**UNITED STATES ENVIRONMENTAL PROTECTION AGENCY**

Mark Robinson  
Plant Manager  
Georgia-Pacific Wood Products LLC  
Highway 13 North  
Columbia, Mississippi 39429

**Re: Georgia-Pacific Wood Products LLC  
Columbia, MS Sawmill  
Facility No. 1740-00008**

#### PROJECT DESCRIPTION AND EMISSIONS CHANGES

### Example VOC Emissions for Kiln 2 and 3

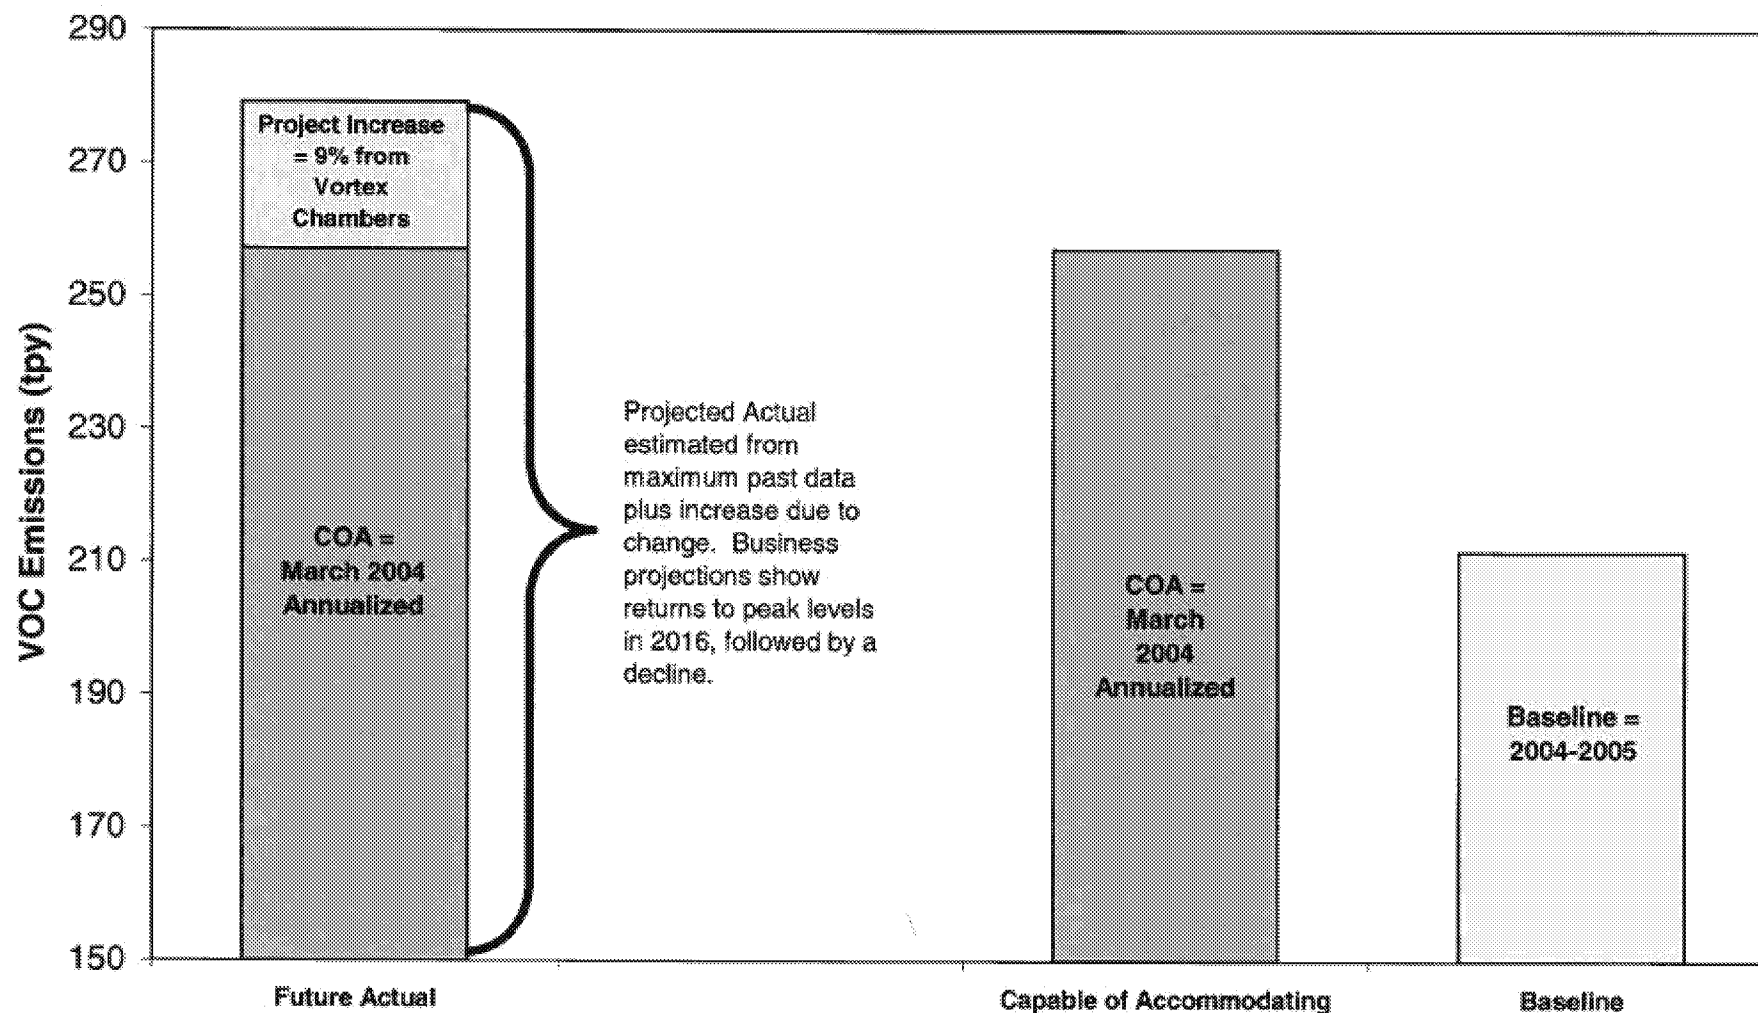
We acknowledge that Georgia Pacific may use the highest demonstrated average monthly operating level during the baseline period as an approximation of the level of operation that the units "could have accommodated" during the baseline period. However, EPA disagrees with the statement that Georgia Pacific "...does not accept this as the limit on excludable emissions during the baseline..." and the statement that the excludable amount under the "demand growth exclusion" is "...the highest amount that the unit could have legally and physically emitted during the baseline..." For PSD applicability purposes, the concept of emissions that "could have been accommodated" is relevant only in conjunction with the source's calculation of "projected actual emissions." That is, once the projected actual emissions from the source following the proposed project have been determined, the source may exclude from the projection "that portion of the unit's emissions following the project that an existing unit could have

accommodated” during the baseline period, and “that are also unrelated to the particular project.” See 40 CFR 52.21(b)(41)(ii)(c). Accordingly, before any given emissions may be excluded under 40 CFR 52.21(b)(41)(ii)(c) on the basis that they result from future demand growth, those emissions must first be part of the projected actual emissions based on “all relevant information” [see e.g., 40 CFR 52.21(b)(41)(ii)(a)] used to make the emissions projection.

In summary, although we do not agree with some of the statements made by Georgia Pacific in the 502(b)(10) change request as explained above, based on the information submitted, we agree with Georgia Pacific’s use of the “demand growth exclusion” for determining PSD applicability for the “Vortex Burners” project. Since the “Vortex Burners” project is not considered a Title I modification, and does not exceed emissions allowable under the permit, the change qualifies as a 502(b)(10) change. If you have any questions, you may contact Heather Abrams at (404) 562-9185 or Yolanda Adams at (404) 562-9214.
